Historical Affairs and Landmark Review Board

HALRB Case 14-20A (HP1400060)

A request by Harold Hofstad, owner of 3619 22nd Street North in the Maywood Neighborhood Historic District, to amend CoA 14-20 in order to reconfigure the number and placement of the solar panels.

TO: HALRB
FROM: John Liebertz, Historic Preservation Planner
DATE: February 9, 2015
SUBJECT: 3619 22nd Street North, CoA 14-20A, Maywood Historic District

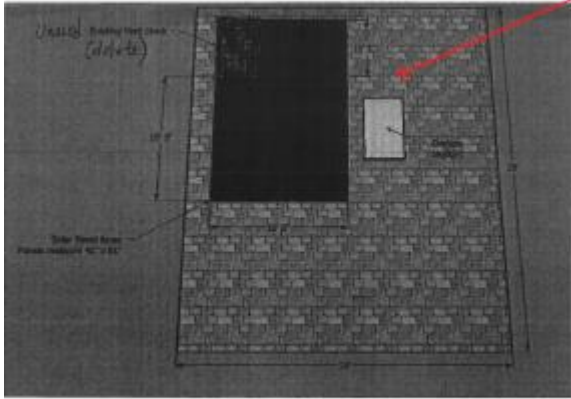
1. Include the new rack specifications
2. Resubmit application with design as shown.
 - a. Five on the top row with three below per sketch (requires moving stack) – See informal sketch below

3. Please update the roof drawing that was in the approved CoA (see below) as part of this submittal package. The drawing reviewed by DRC was difficult to interpret due to quality of image.
